RECONSTRUCTION OF SR 3 / US 19/41
Project No. NH-001-4 (47)
Spalding County, Georgia

Value Engineering Study Report
Preliminary Design Submittal

November 2008

ALTERNATIVE NO.: **A-10**

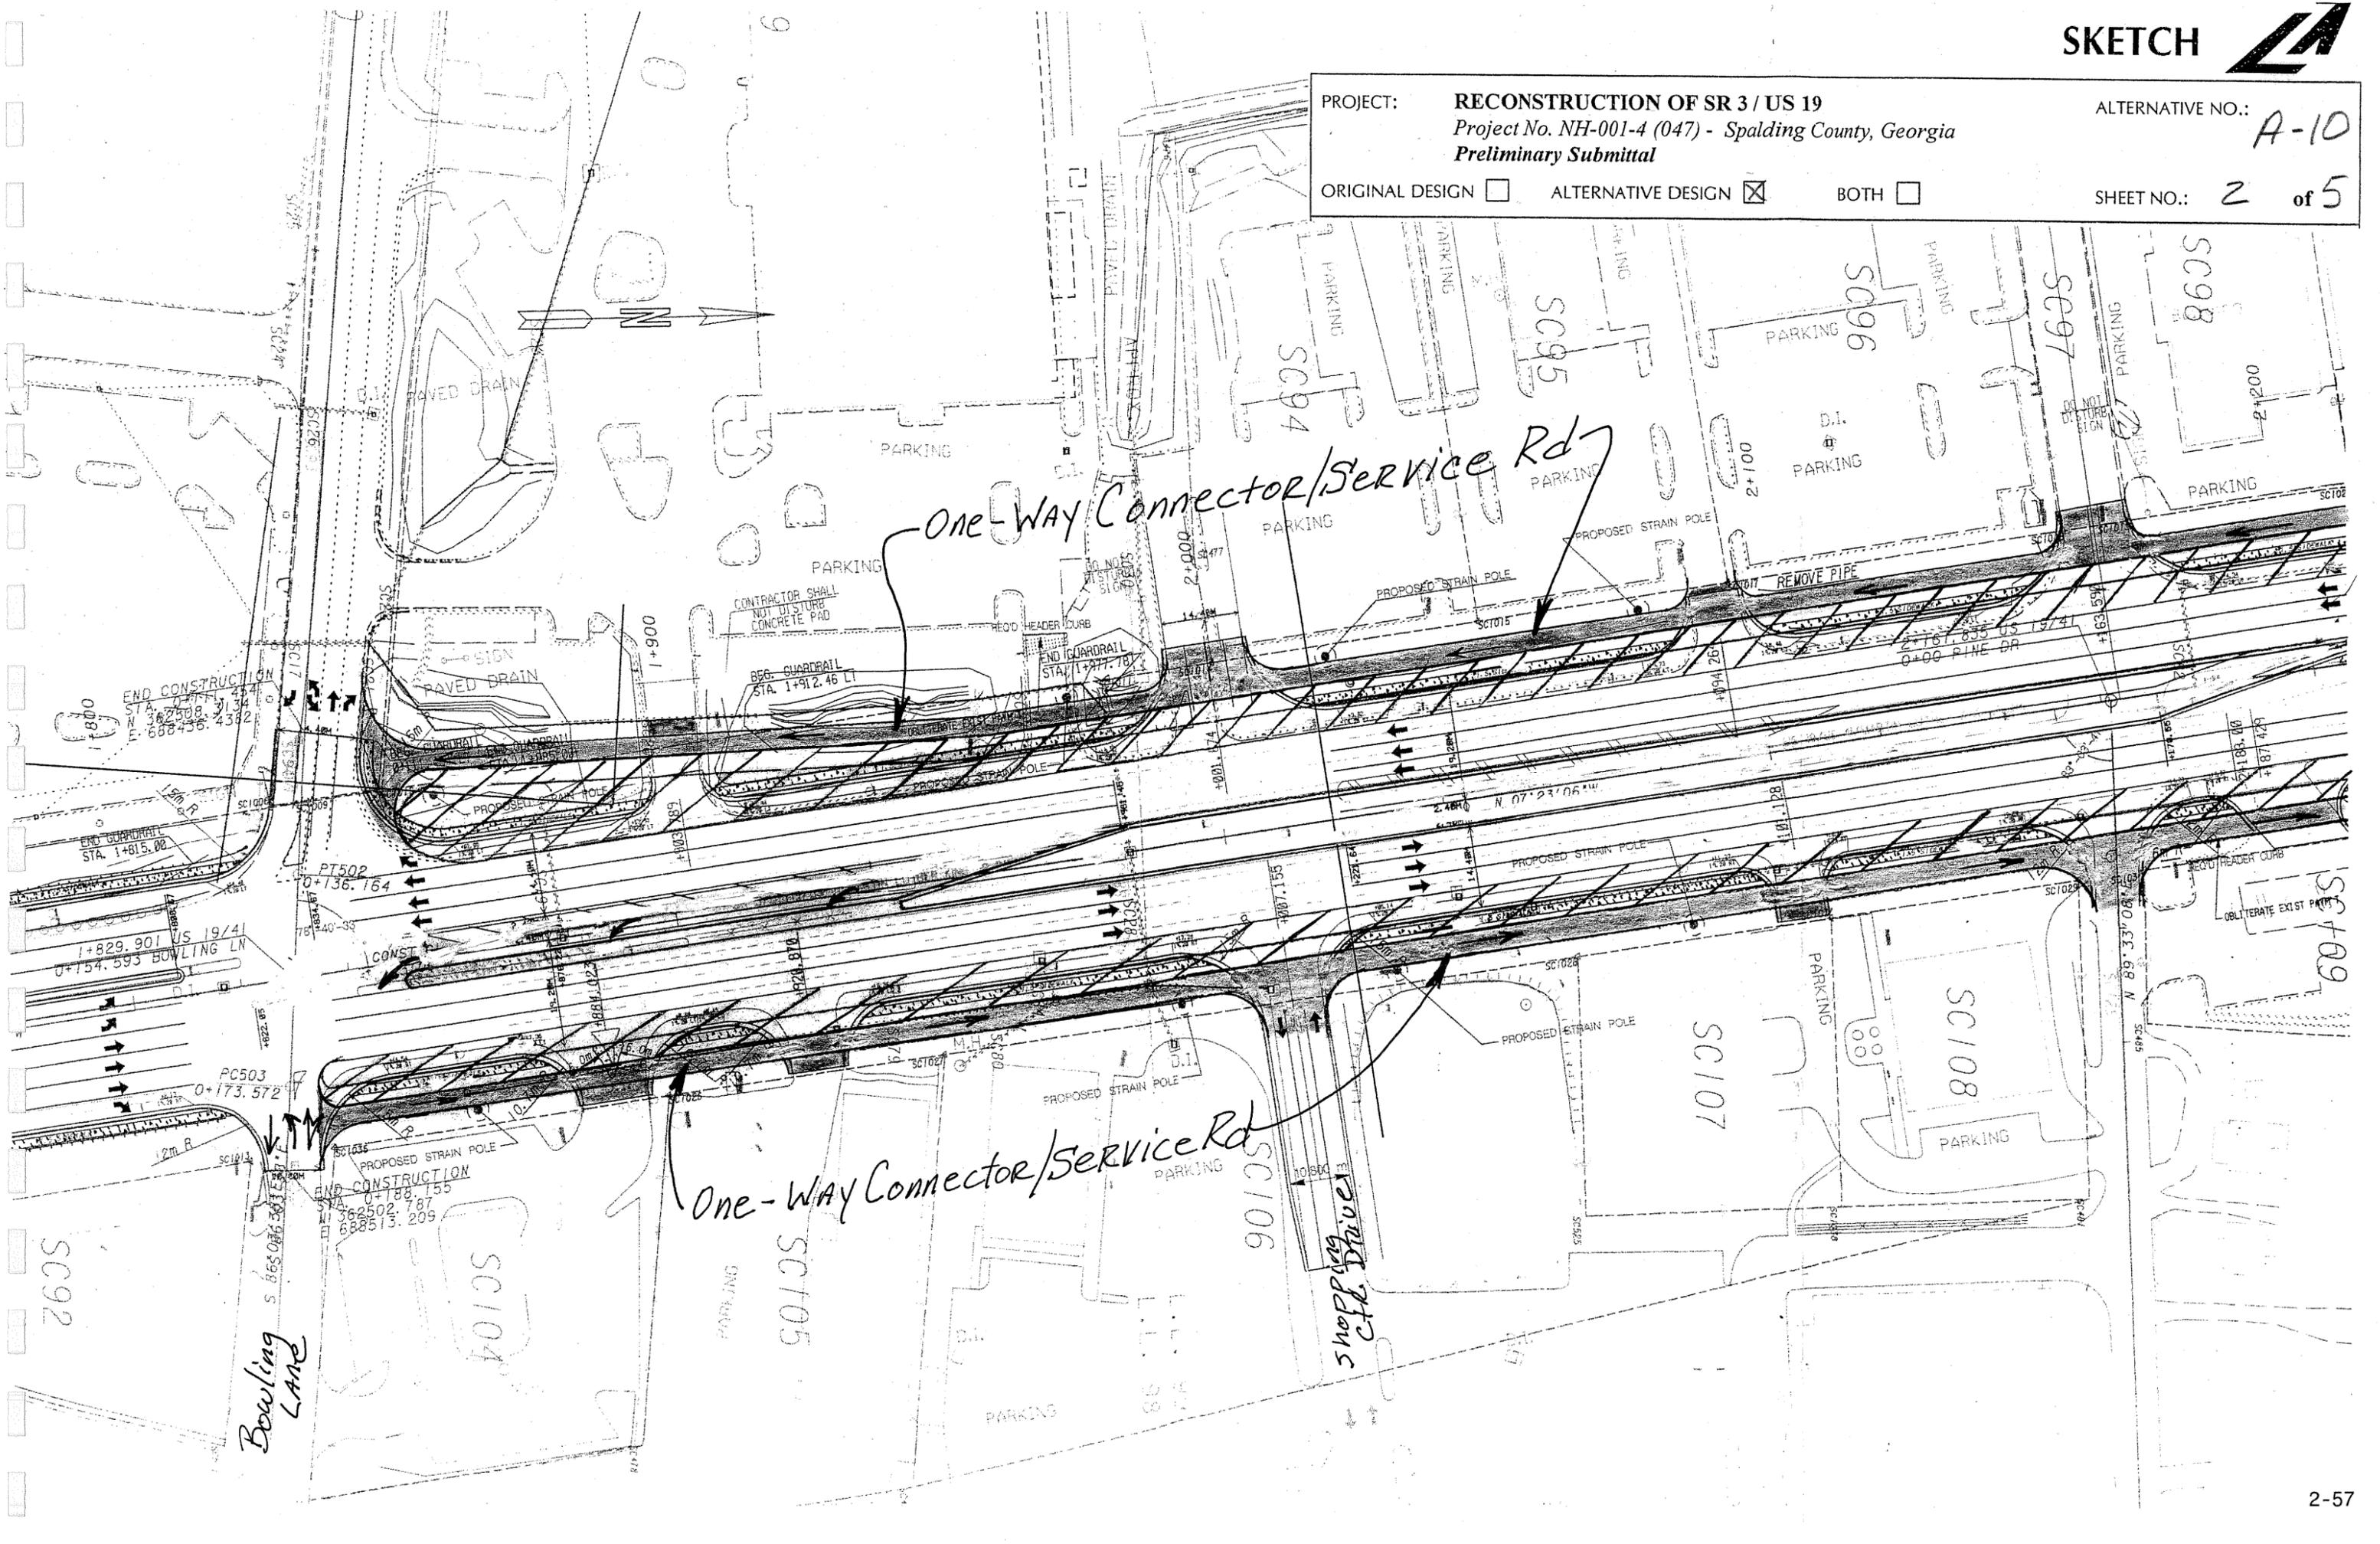
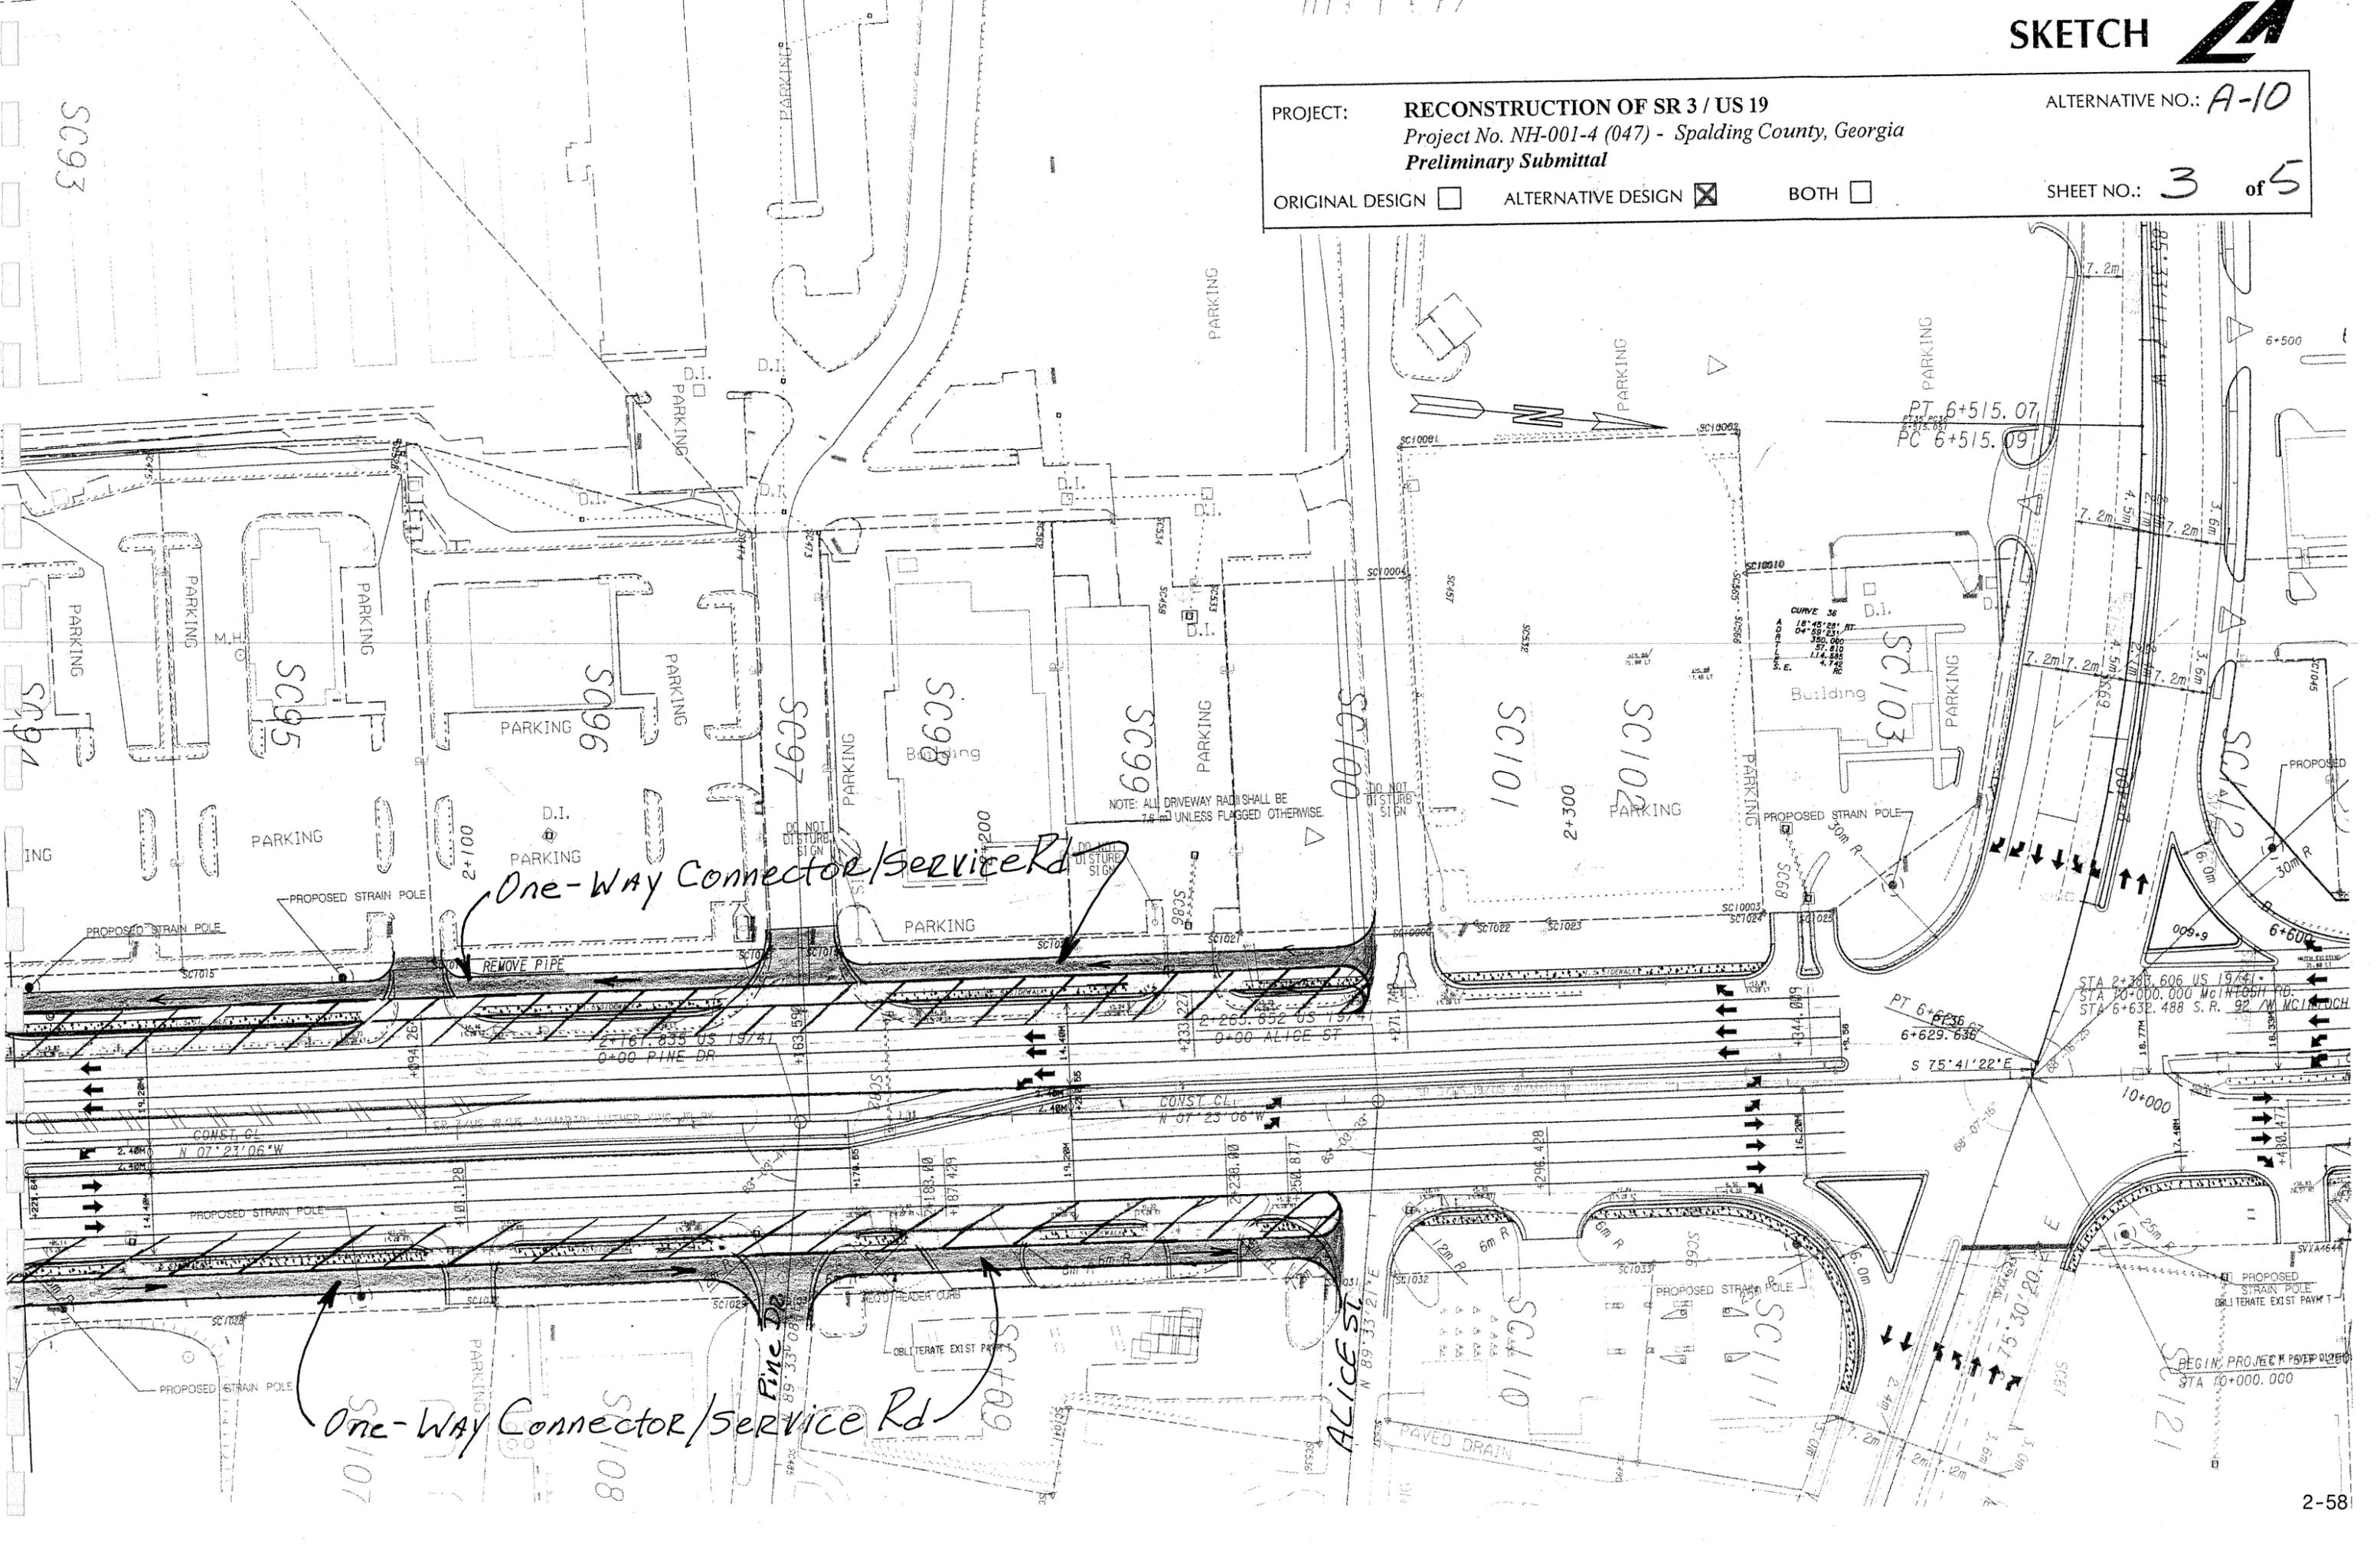
Do not add outside lanes to US 19/41. Keep the raised, curbed median for US 19/41 and add left-turn lanes. Add one-way connector/service roads in both the northbound and southbound directions for local access to businesses.

This alternative design would close the proposed median opening at ACCLOU shopping center drive and allow the median opening at Bowling Road to be a full-directional intersection. The present design restricts all left turns except for northbound US 19/41.

ALTERNATIVE NO.: **A-11**

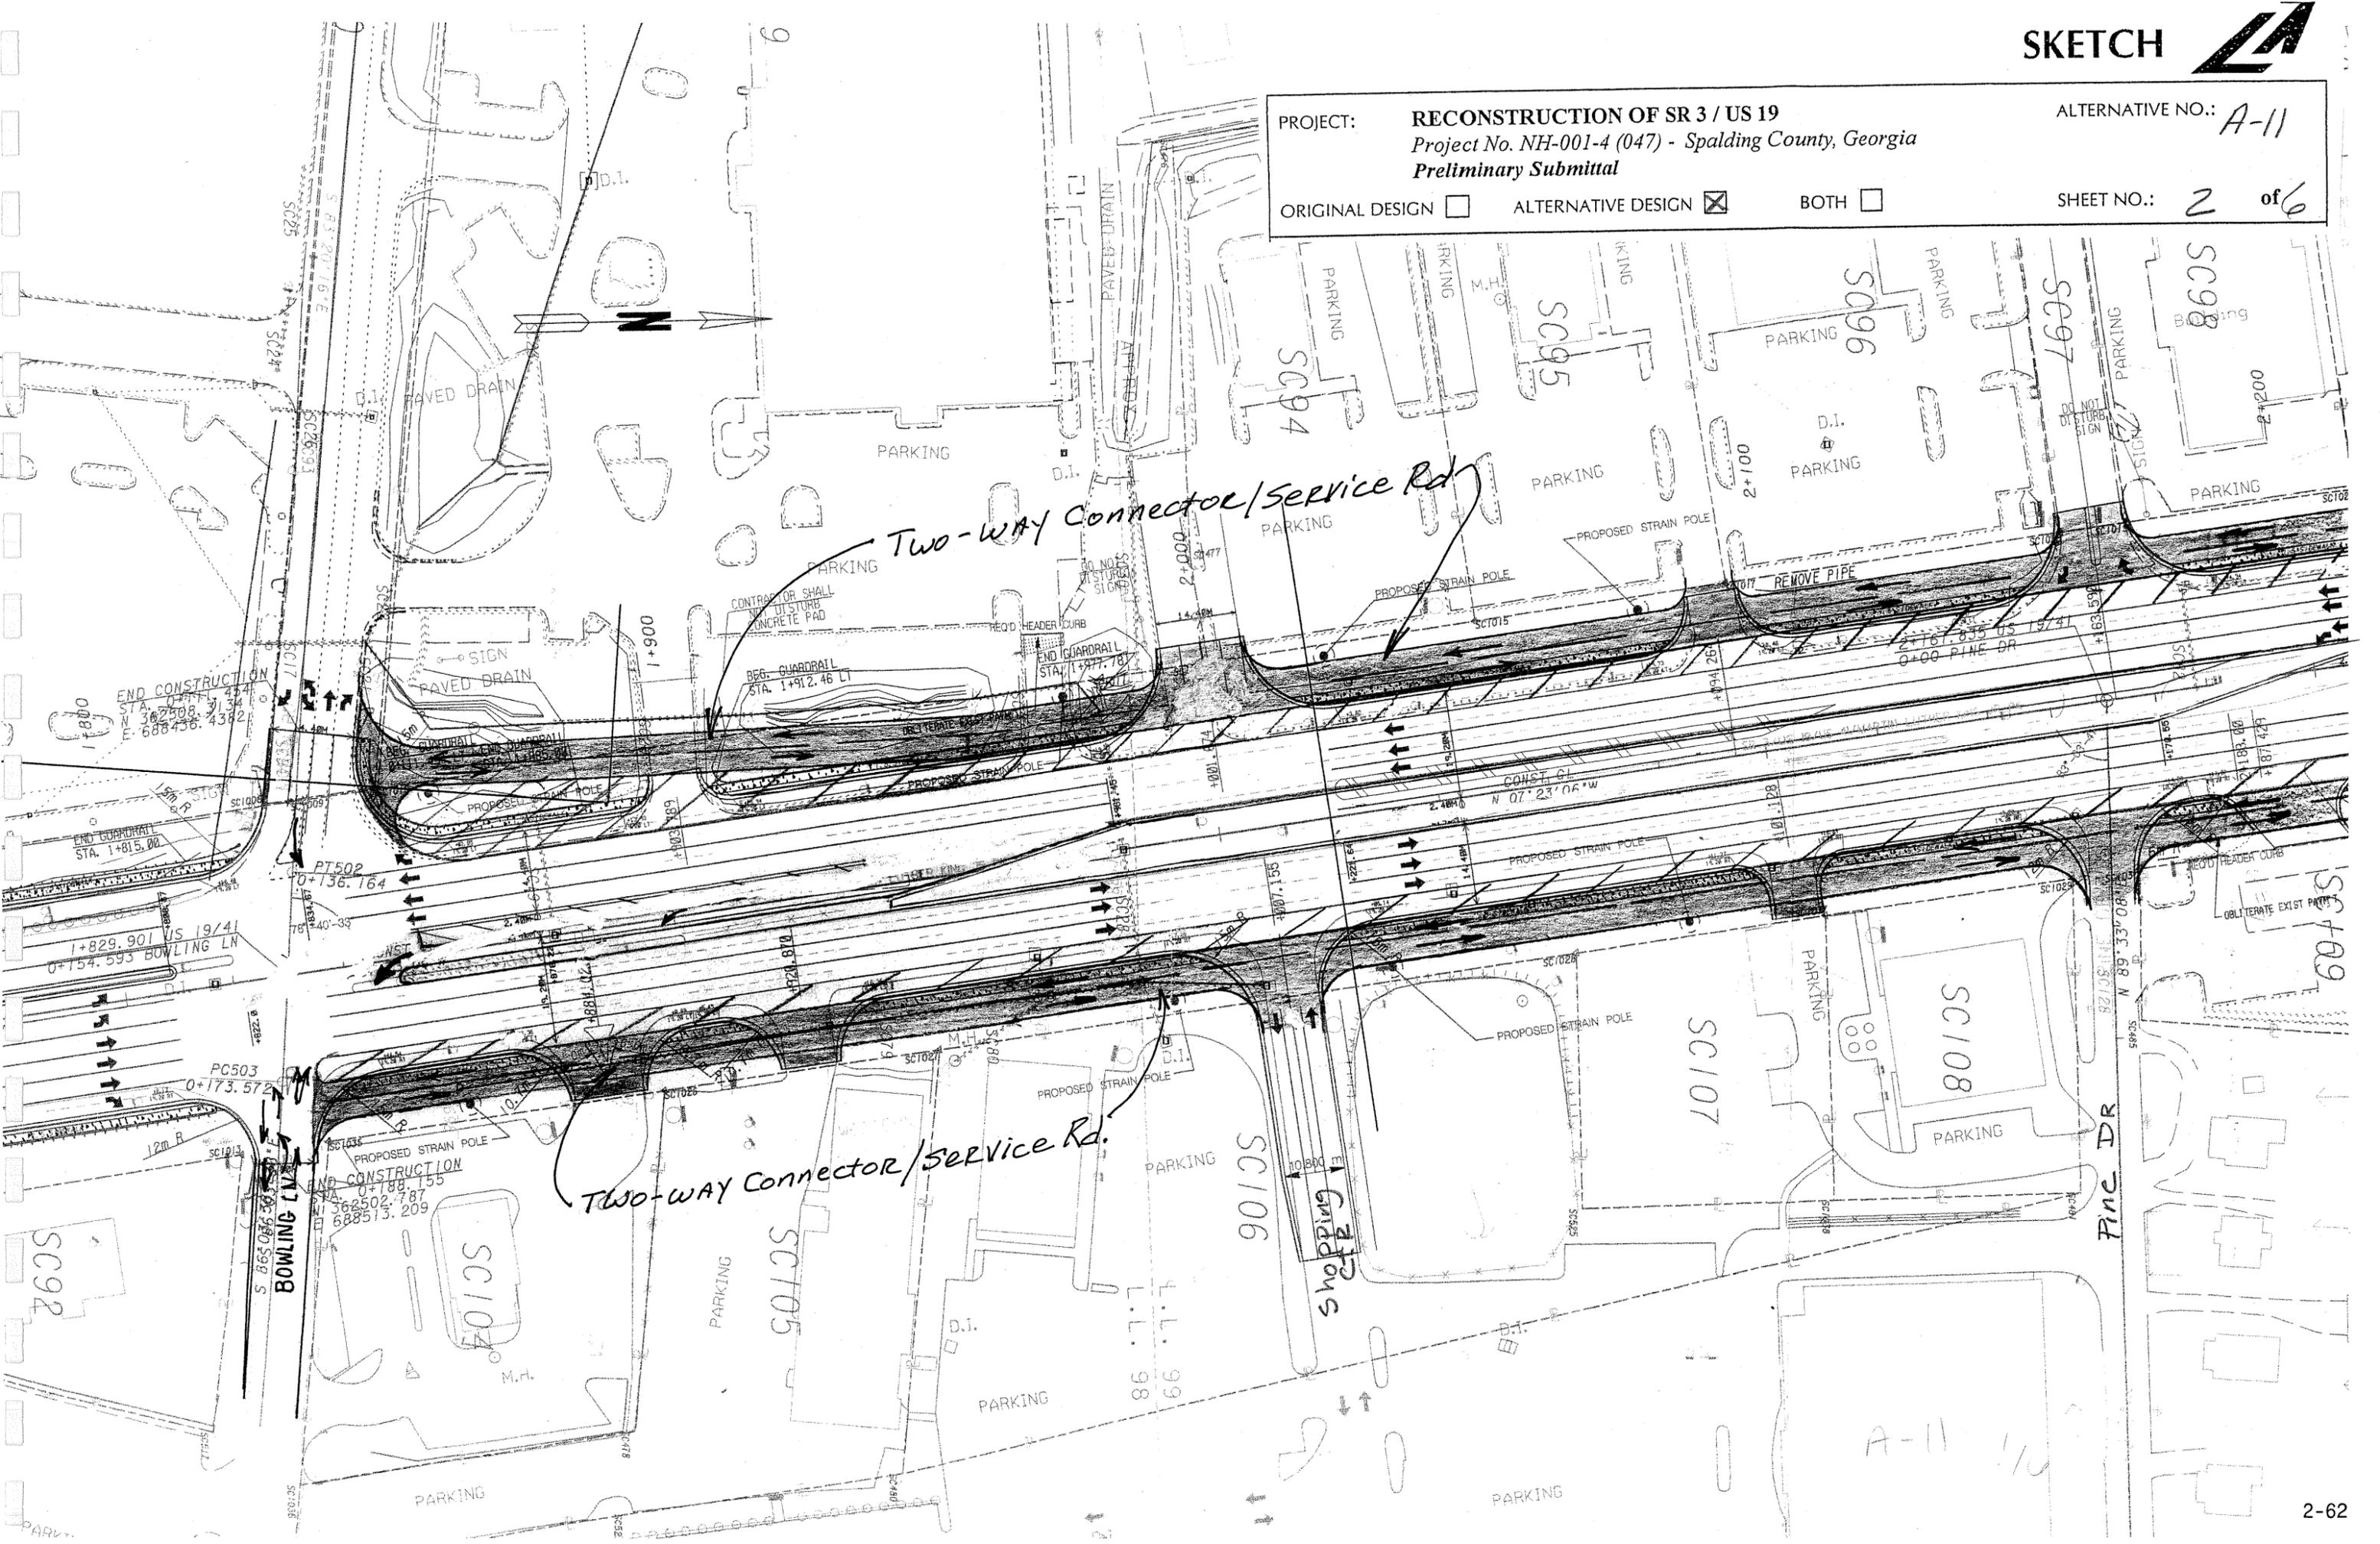
Do not add outside lanes to US 19/41. Close the median to provide left turns with a raised (6 in.) median. Add two-way connector/parallel service roads to US 19/41 on the northbound and southbound directions for access to local businesses.
